Location Address: 1203 N. Federal Highway, Hollywood, Florida 33020

Technical Advisory Committee  
City of Hollywood  
Development Services Planning Division

RE: Site Plan Design for 6,318 sf spa and restaurant  
Federal Spa and Restaurant  
1203 N. Federal Highway

80' TOTAL RIGHT-OF-WAY  
**N. FEDERAL HIGHWAY**

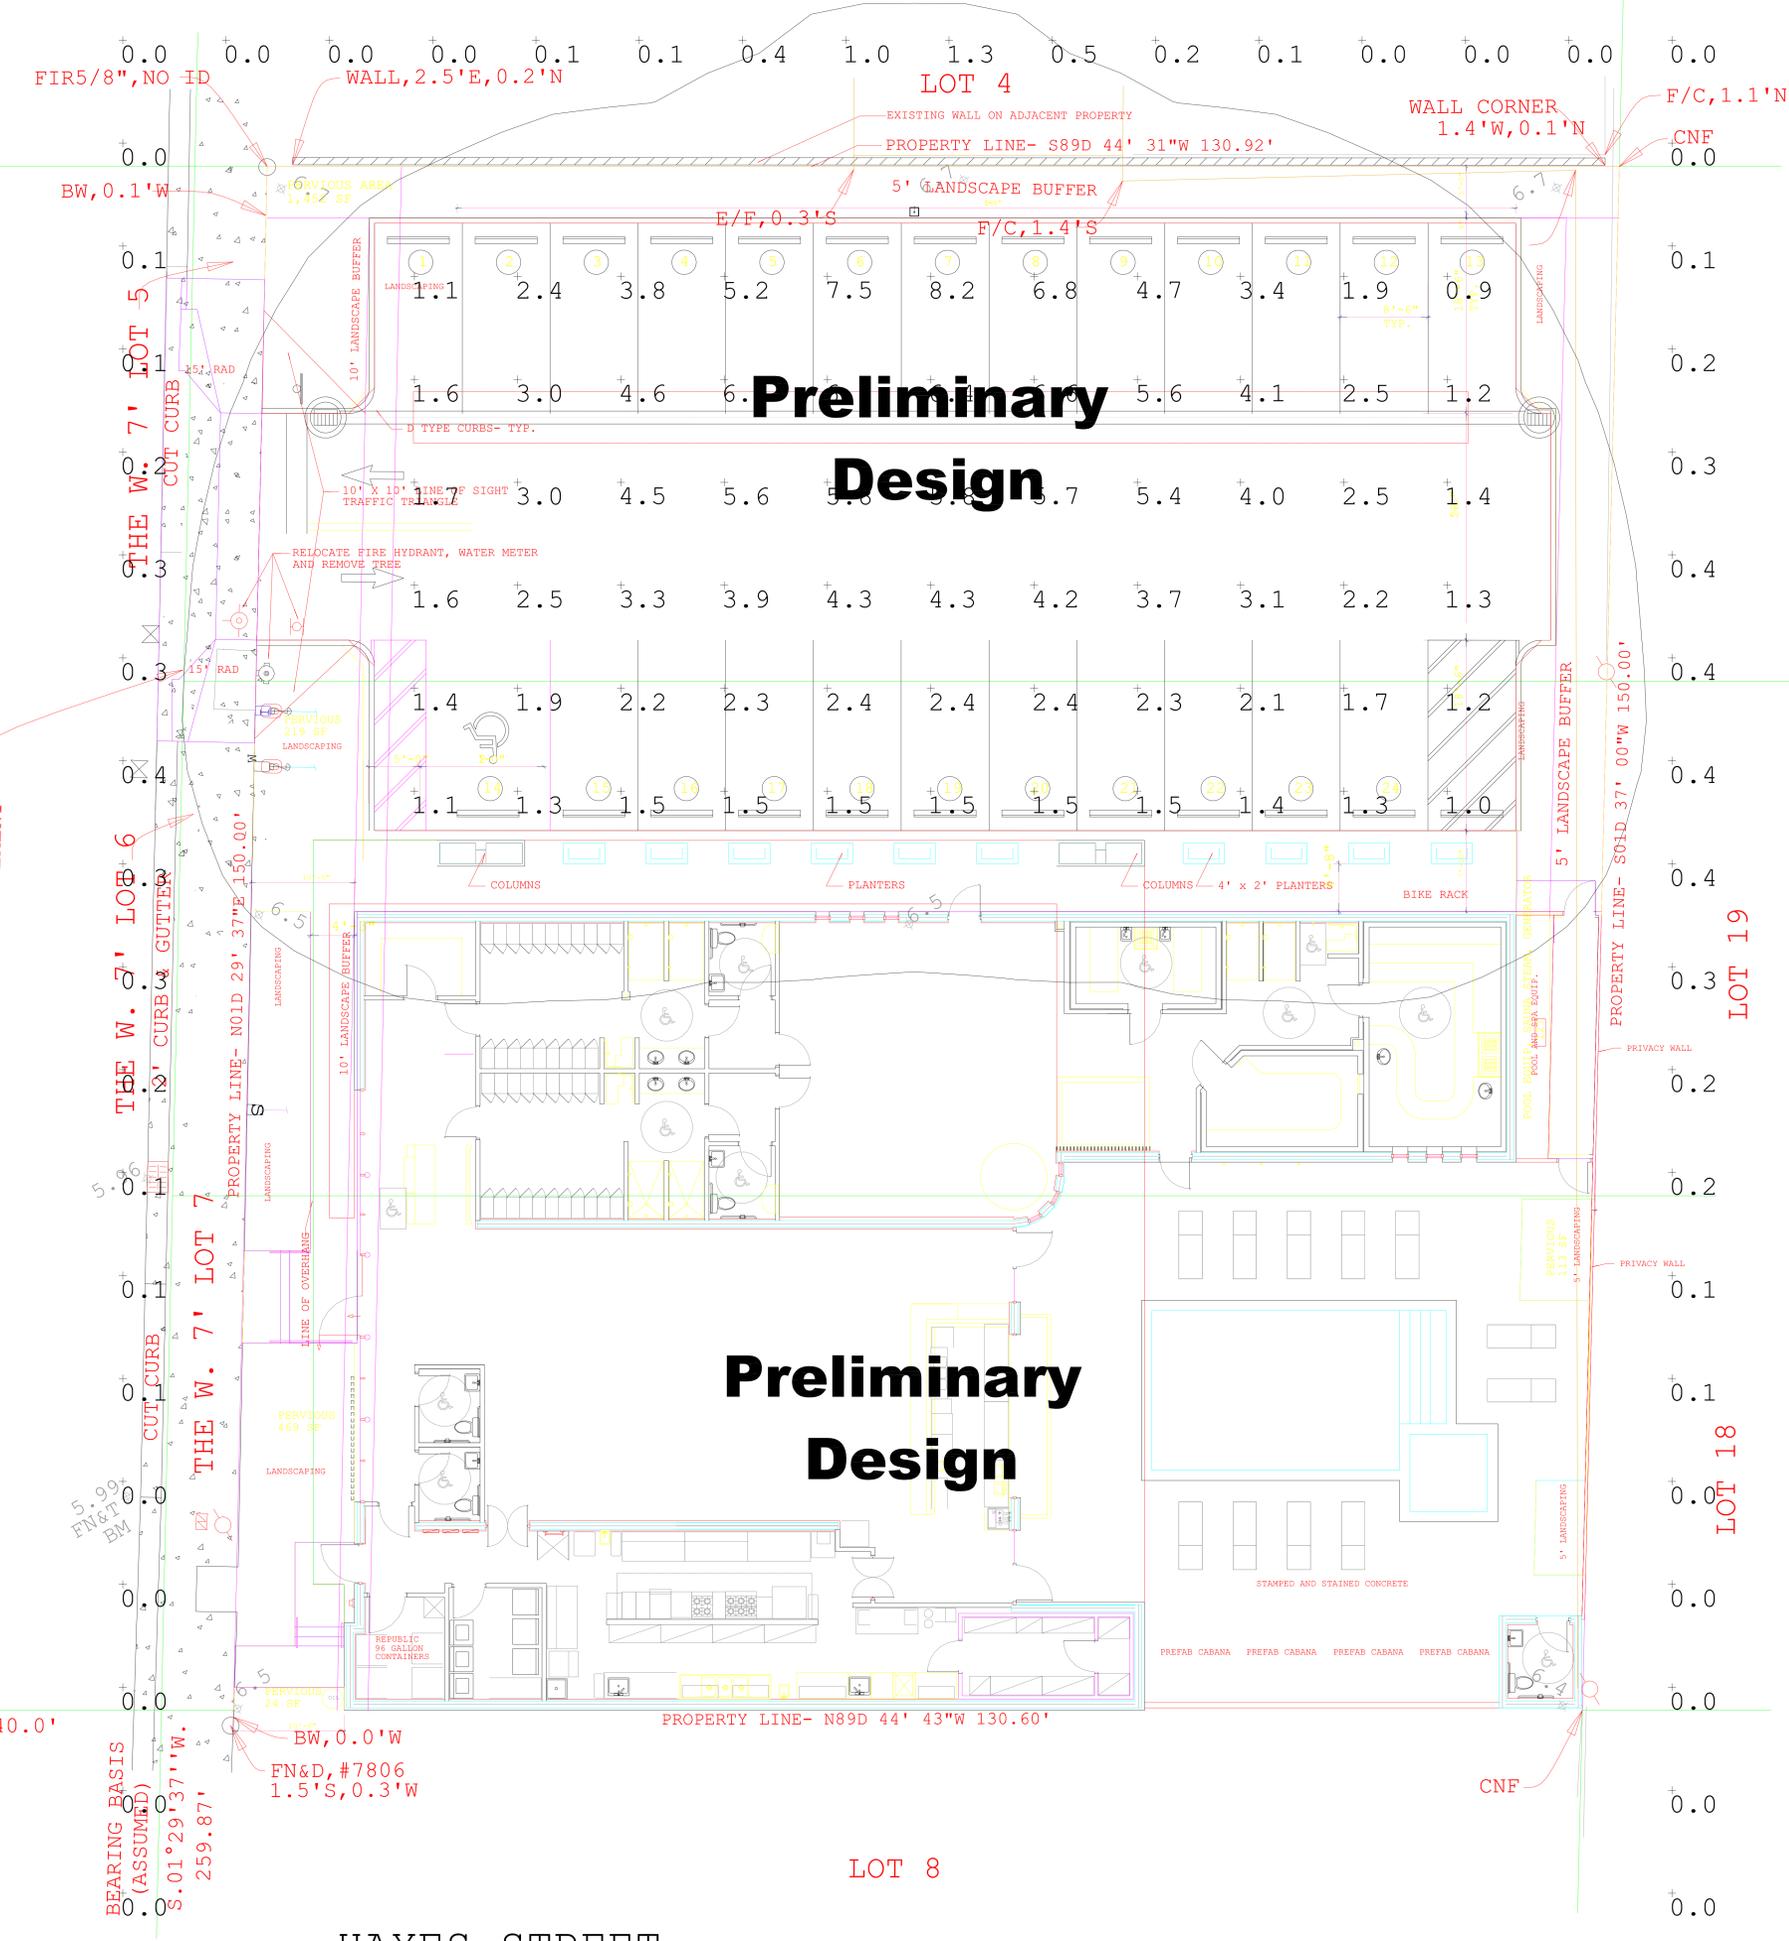
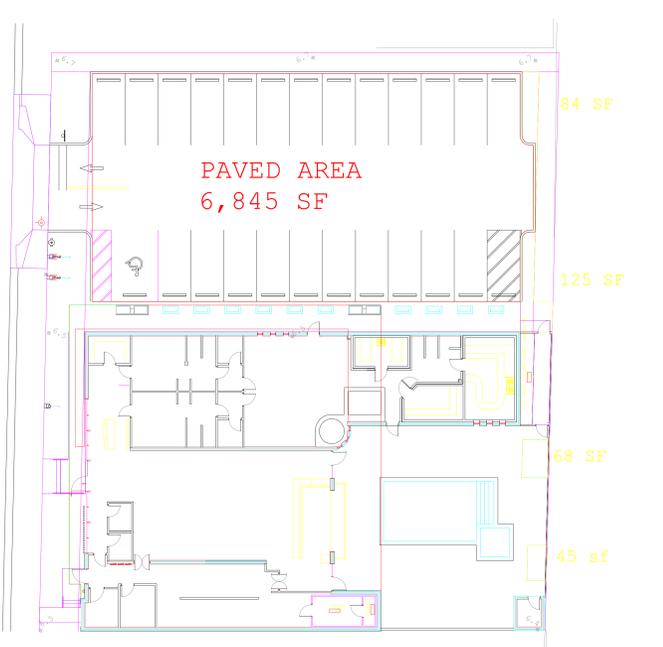
1. On Site Plan, dimension leaders and texts are overlapping with ADA accessible route and drainage lines making text not legible.

2. On Site Plan, clarify where the 18'-6" parking stall depth starts and ends. Properly dimension the curb width and clarify the curb dimension, Site Plan shows 6", civil details show 8".

3. For the parking lot bump out, provide dimension for the curb width. The bump out should be minimum 3' plus the width of the curb.

4. On Site Plan, indicate width of the proposed driveway curb cut at the property line.

5. Indicate the distance between road edge of pavement to the property line on Site Plan and provide sight visibility triangle per Chapter 155.12 of the City Code.

**Response: Adjusted dimensions.**

**Response: Both show 6" curbs.**

**Response: We added a extra space, 3'-8" which is hatched for easy turn around.**

**Response: Driveway curb cut is 22' and we added to site plan.**

**Response: Revised sight visibility triangle to 12' per section.**
